Kalix Solenoid Valve Change

TECHNICAL BULLETIN

OAS0048B

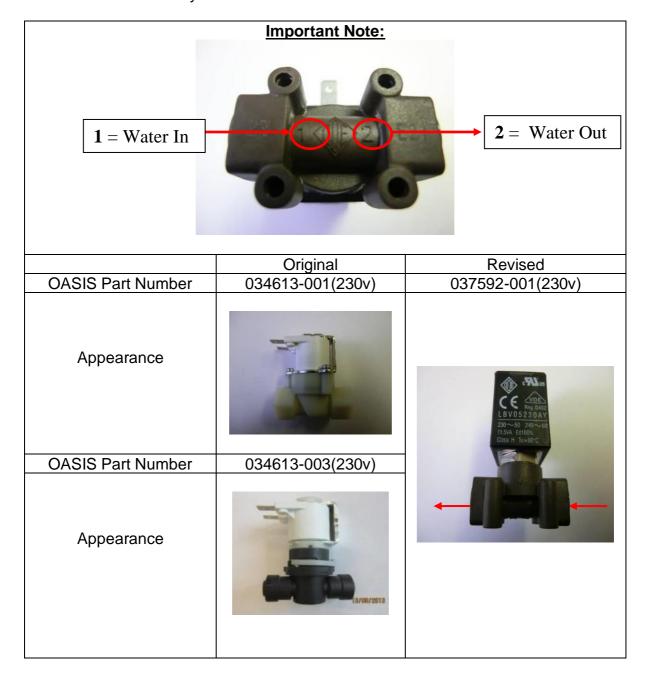
In order to improve performance of Kalix POU watercoolers, OASIS are introducing a new range of solenoid valves for use in all 230V products – cook and cold, hot and cold, and carbonated models. Extended testing of the new valves show that they are more resistant to fluctuating water pressures, prevent dripping and can withstand higher pressures without leaking.

These valves are a direct replacement for the original equipment – please note that the quick-fit connection that screws to the valve must also be changed.

Service kits have been created to supply all necessary parts to replace a faulty solenoid valve assembly.
